Re: Docket No. 40-8502, License No. SUA-1341

Enclosed please find five sets of replacement pages for insertion into the License Renewal Application (LRA) dated May, 2008 for the above referenced license. The revised pages address a number of key improvements and modifications to the document including:

This submittal package includes five sets of replacement pages for text and figures in Sections 1.0, 3.0, 4.0, 5.0, 6.0 and 7.0. Each set also includes an index of page changes identifying:

Enclosures: Five sets of page replacements for SUA-1341 License Renewal Application – May 2008.

Figure 3.11  
Irigaray Processing Facility  
Process Flow Diagram

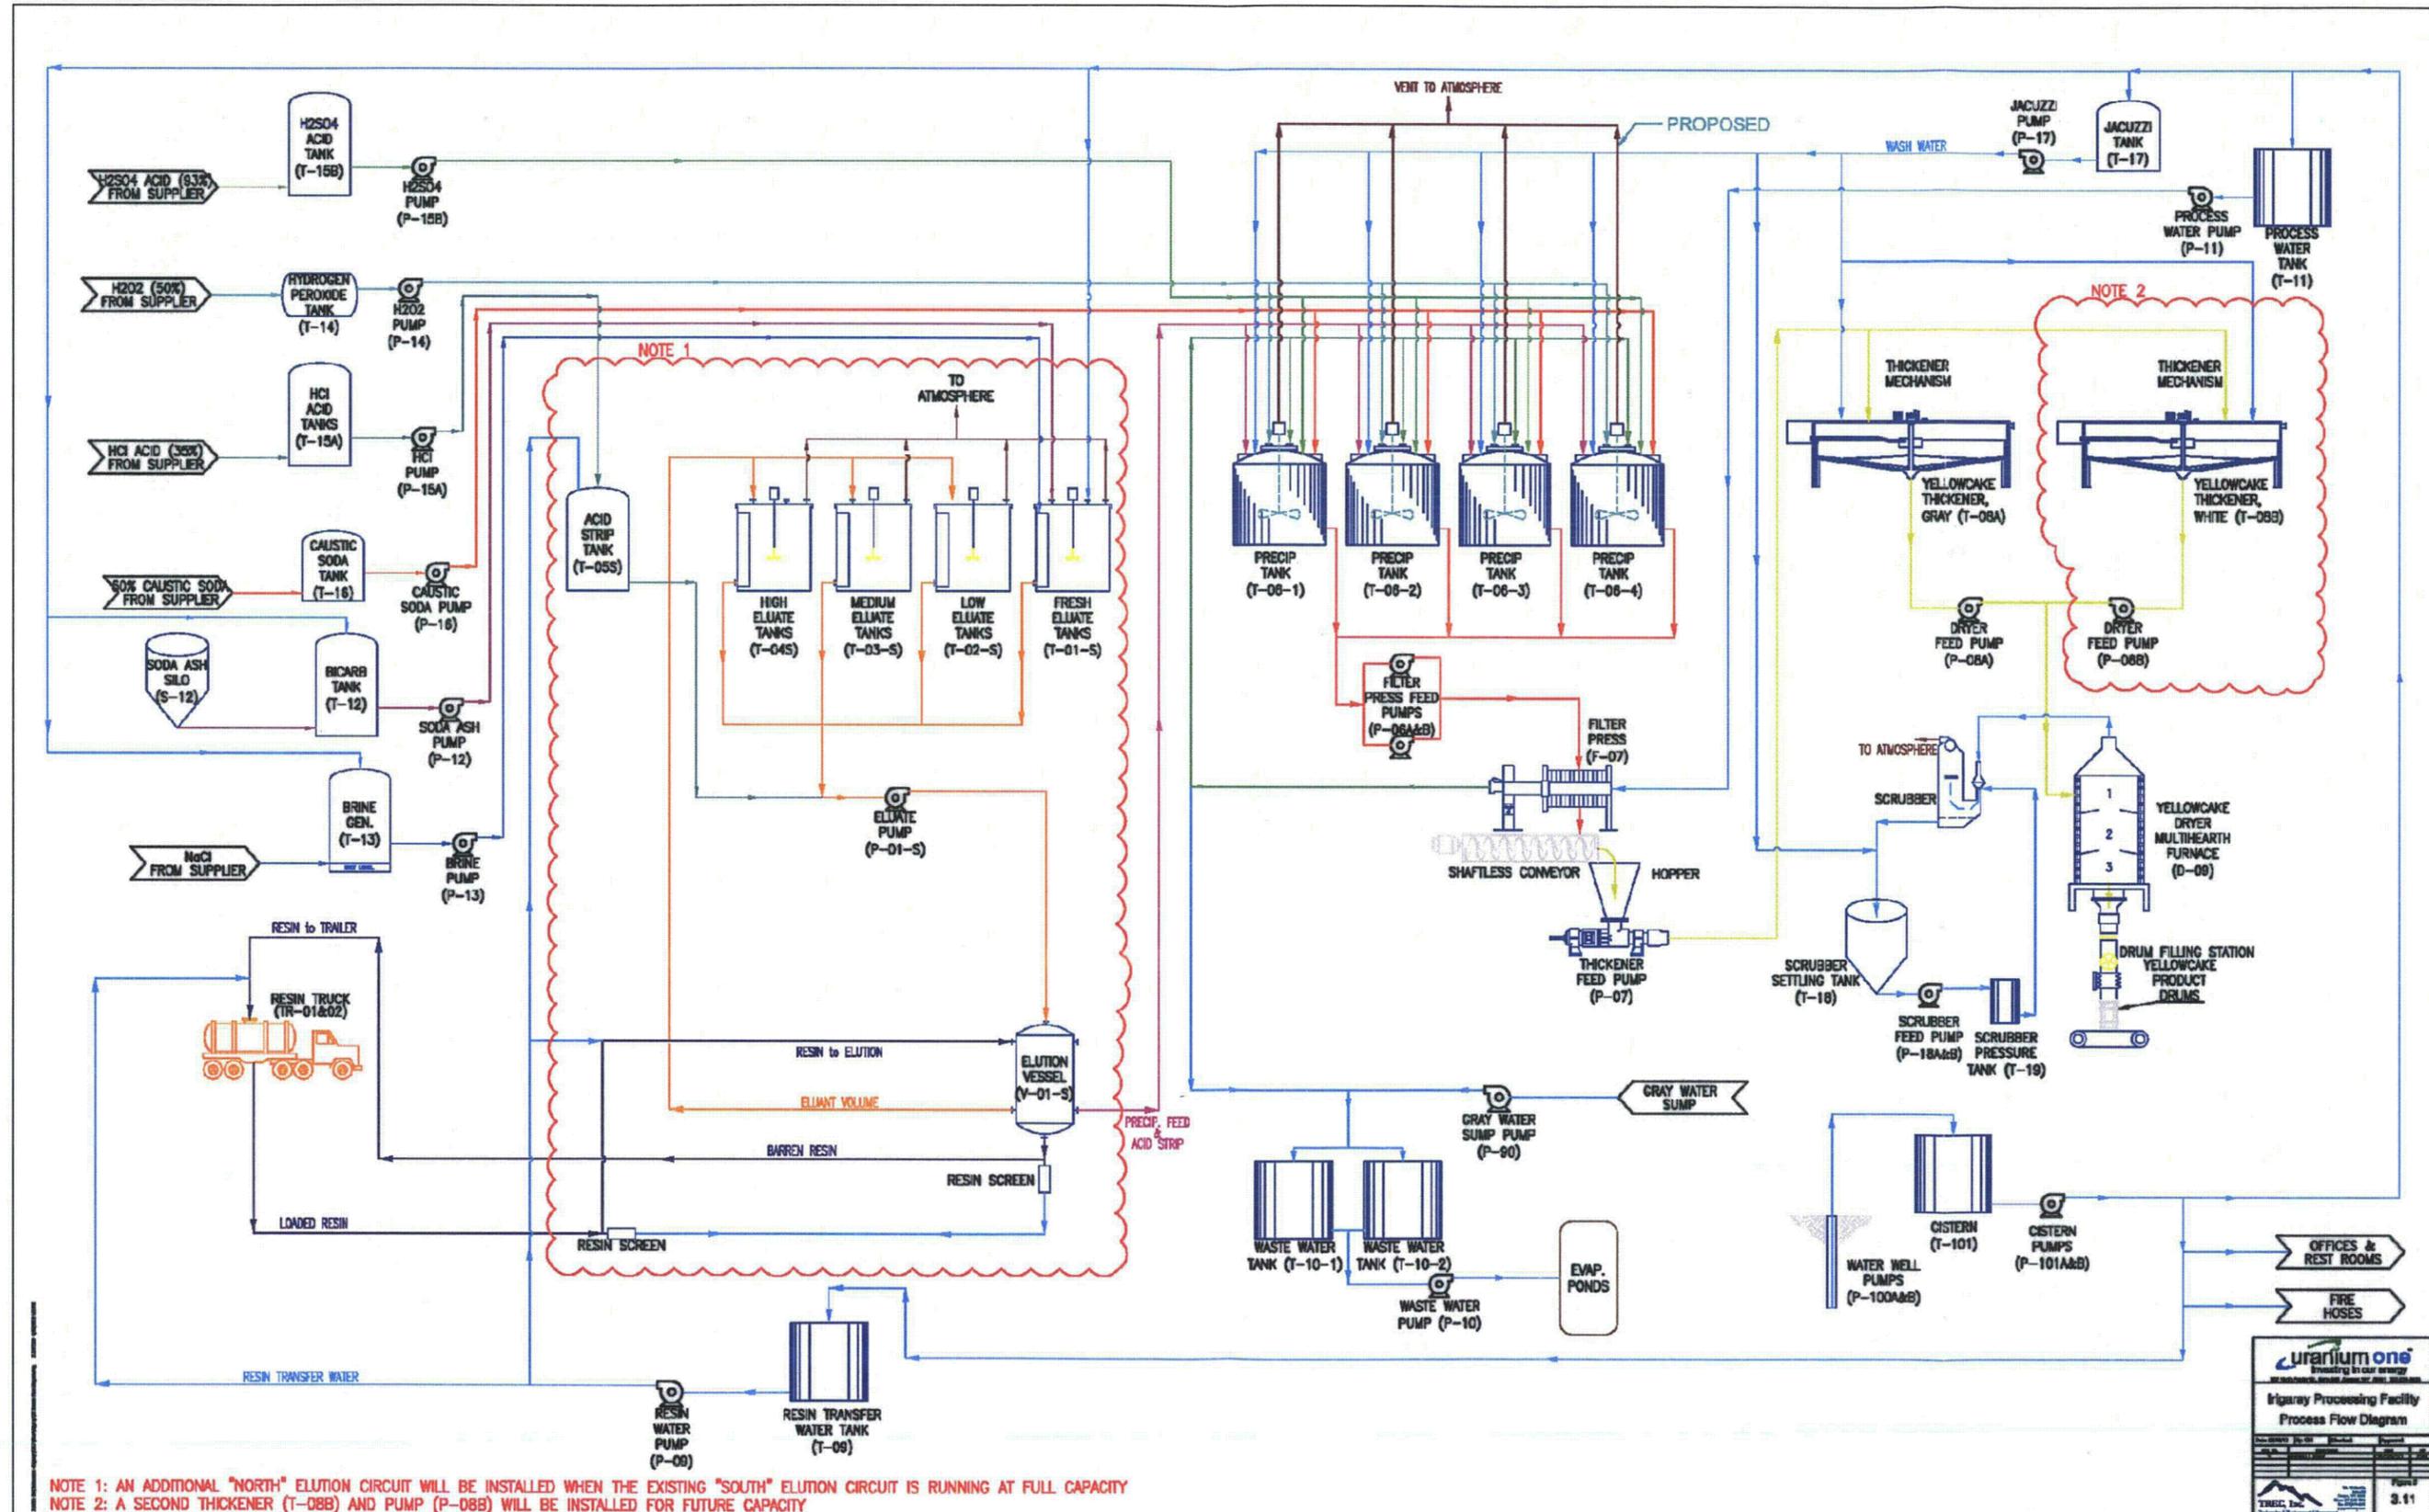
Page(s) Removed	Page(s) Inserted	Description of Change
3-35	3-35	New Figure 3.11 "Irigaray Processing Facility Process Flow Diagram"
3-36	3-36	Section 3.4.1.8 – Adds sentence to paragraph one discussing equipment list. Adds new Section 3.4.1.9 Chemical Storage Facilities.
N/a	3-36a following page 3-36	Continues Section 3.4.1.9 Chemical Storage Facilities.
N/a	3-36b following page 3-36a	Continues Section 3.4.1.9 Chemical Storage Facilities
3-37 & 3-38	3-37 & 3-38	Updates Table 3.3 "Irigaray Plant Equipment List"
N/a	3-38a following 3-38	Continues update of Table 3.3 "Irigaray Plant Equipment List"
3-39	3-39	Updates the individual IX column capacity from 600 to 1,200 gpm in first paragraph of Section 3.4.2.2
3-40	3-40	Deletes operated "manually", reference to "day tank" and "pH instrumentation in the makeup tank" in paragraph three. Adds reference to "sulfuric acid storage tank" and revises text in last paragraph.

Project Name: **W. LOW CREEK**      Figure #: **3-12**      REV: **0**

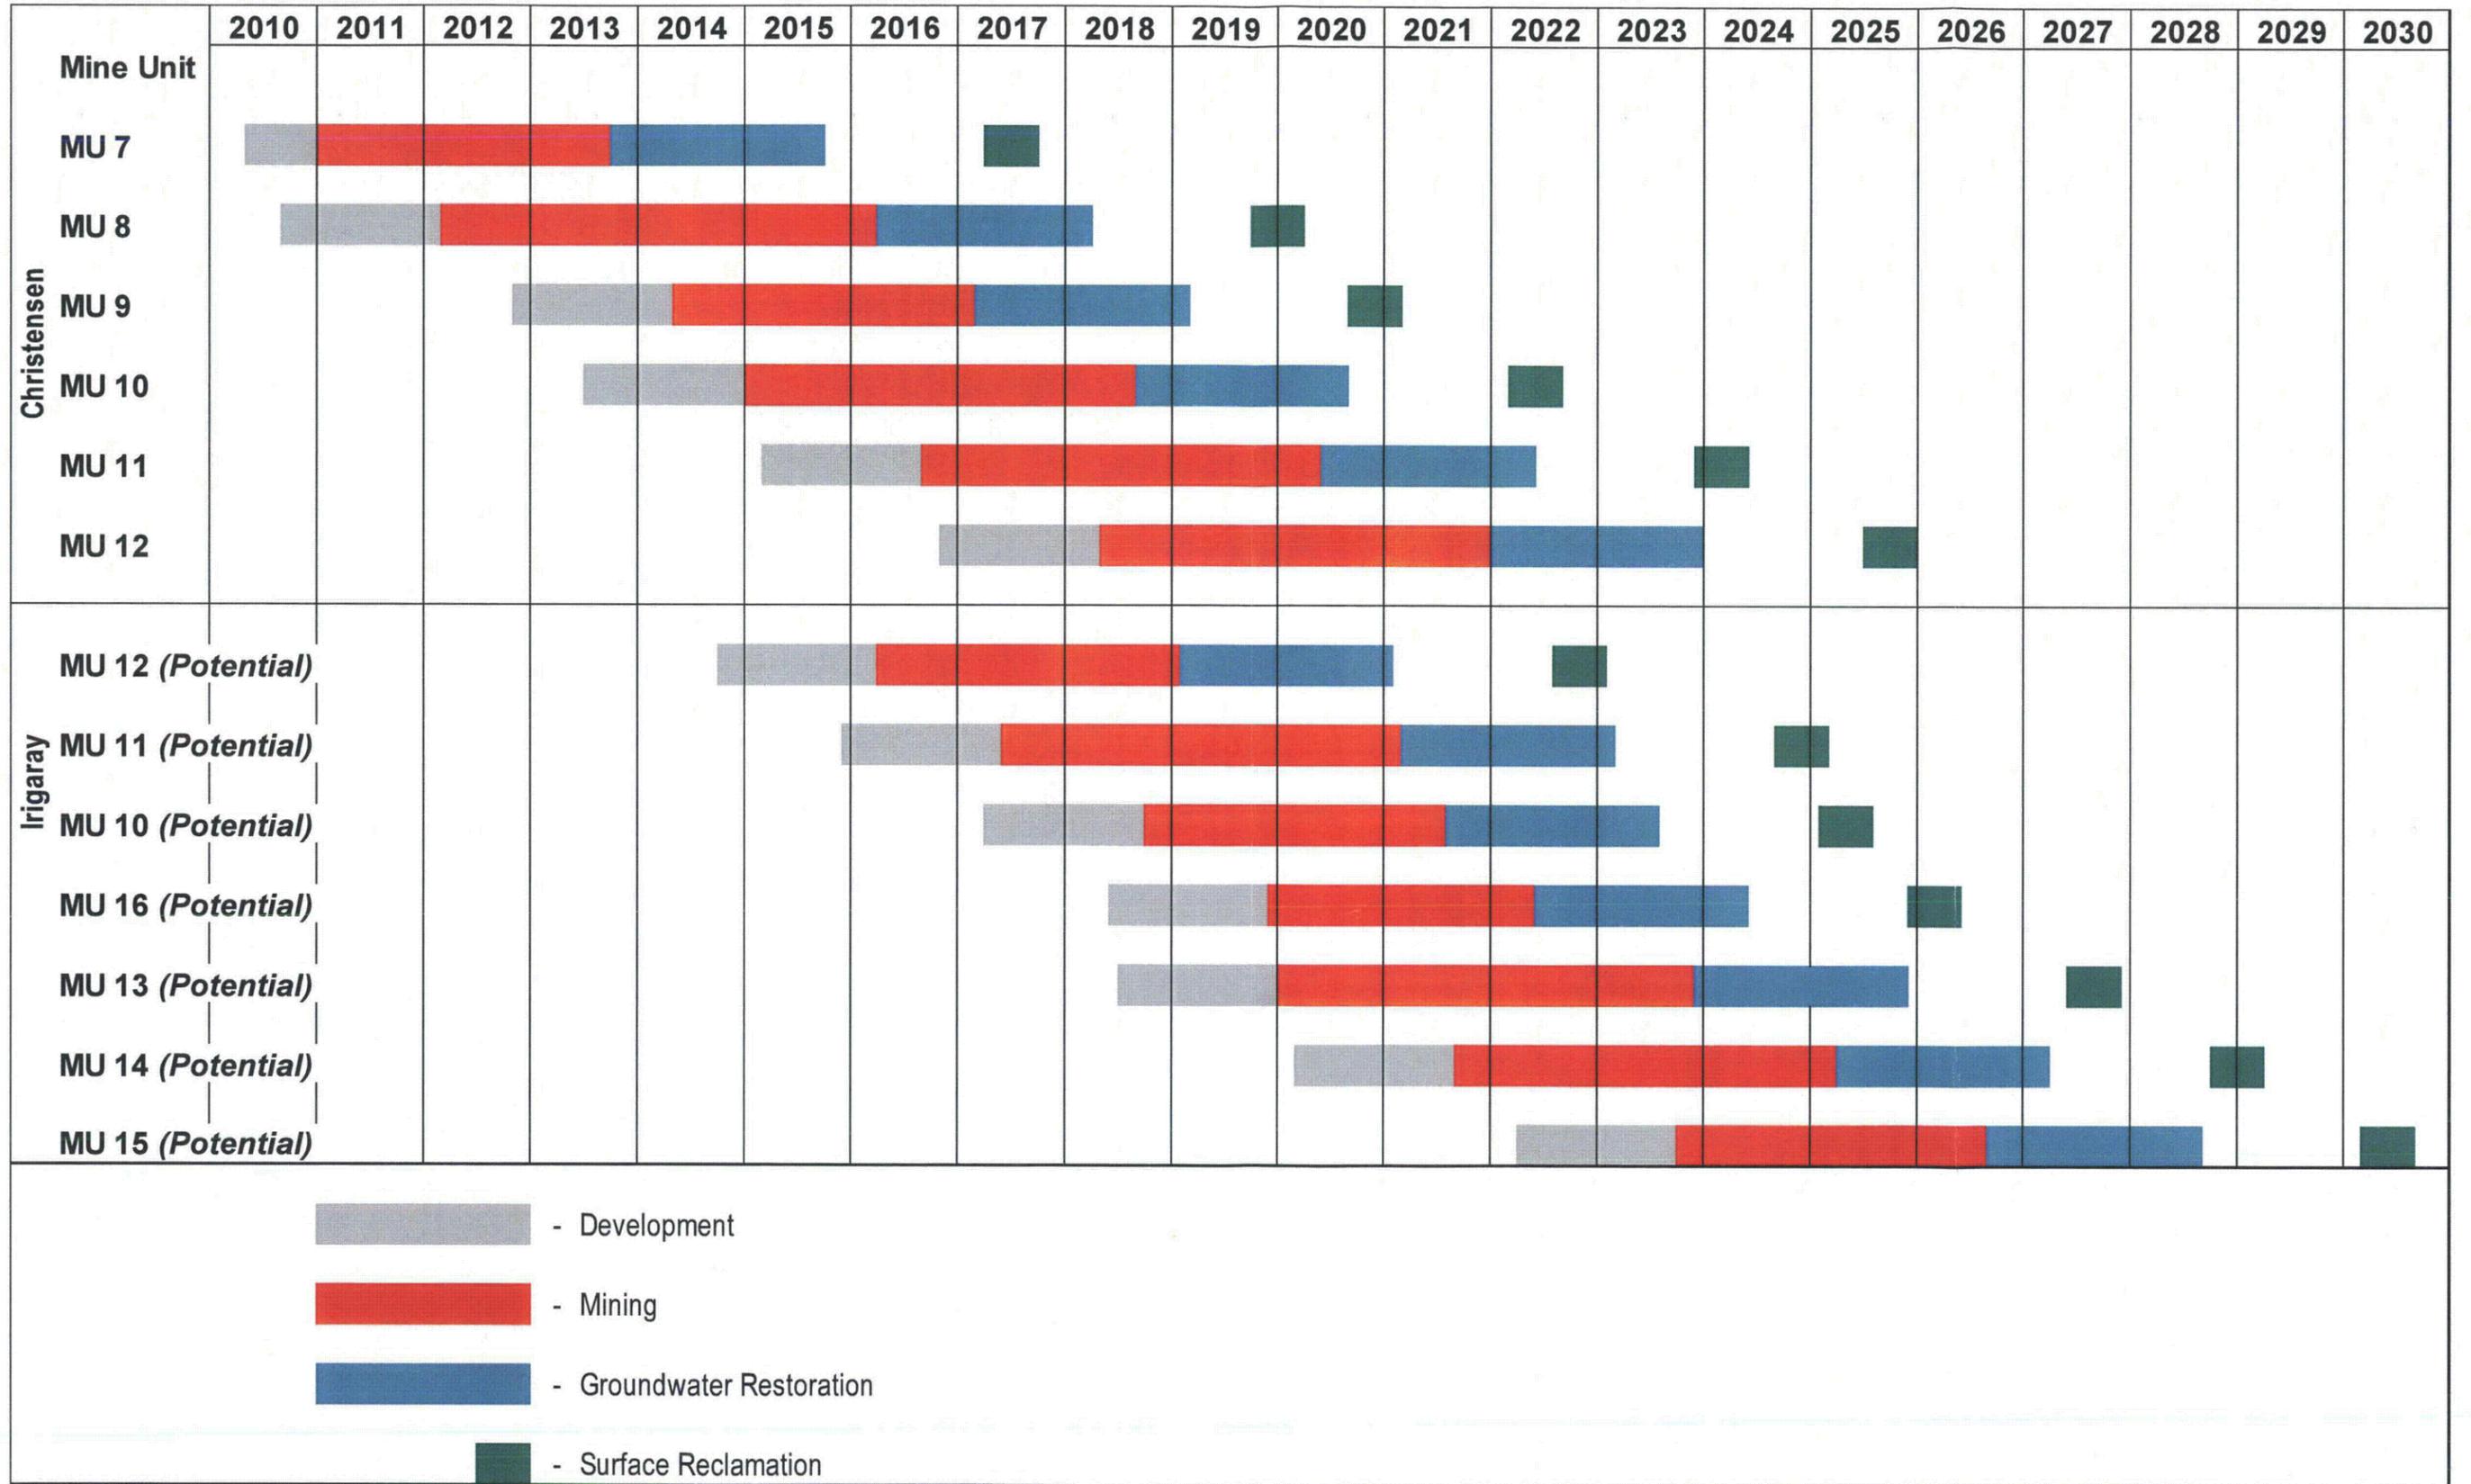
3-41	3-41	New Figure 3.12 Christensen Ranch Facility General Arrangement Diagram.
3-42	3-42	Section 3.4.2.3 - Removes "Material Balance" from title and reference to "material balance" in the first paragraph Adds bag filter to last sentence of Section 3.4.2.3.
3-43	3-43	New Figure 3.13 Christensen Ranch Satellite Process Flow Diagram.
3-44	3-44	In section 3.4.2.4 corrects spelling of "makup" to "makeup" and changes "currently" to "may be" stored in reference to permeate storage.

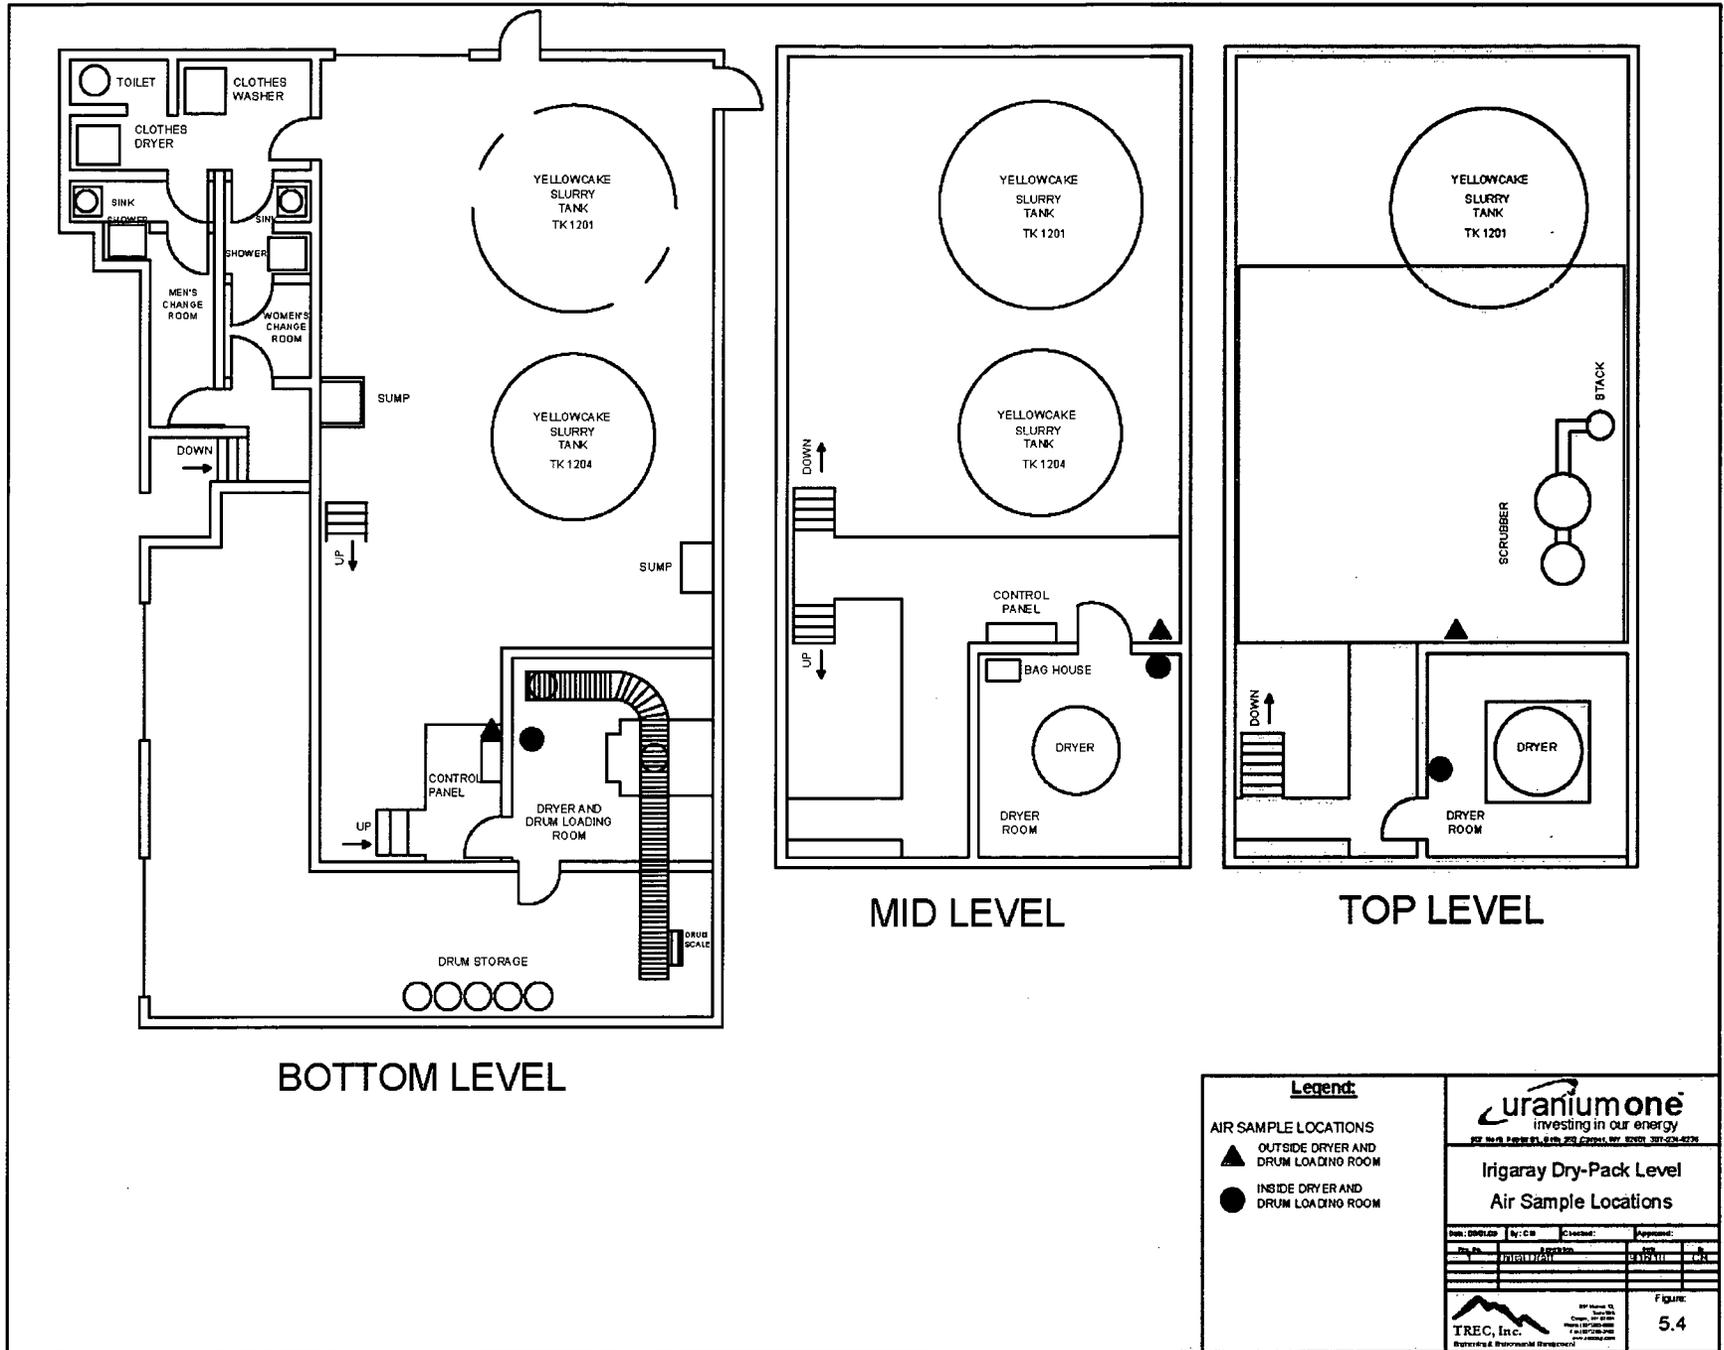
5-22a	5-22a	Continues further discussion on the determination of uranium concentrations to Area Sampling in response to February 18, 2010 Open Issues Related to the NRC's Safety Review: 5.7.3 Comment B.
5-22b	5-22b	Adds Table 5.2a in response to February 18, 2010 Open Issues Related to the NRC's Safety Review: 5.7.3 Comment B.
5-23	5-23	Paragraphs four and five - Deletes SOP references (HP-6, 13, 15, 18 & 26), adds reference to SUA-1341.
5-25	5-25	Updates Figure 5.4 Irigaray Dry Pack Level Air Sample Locations.
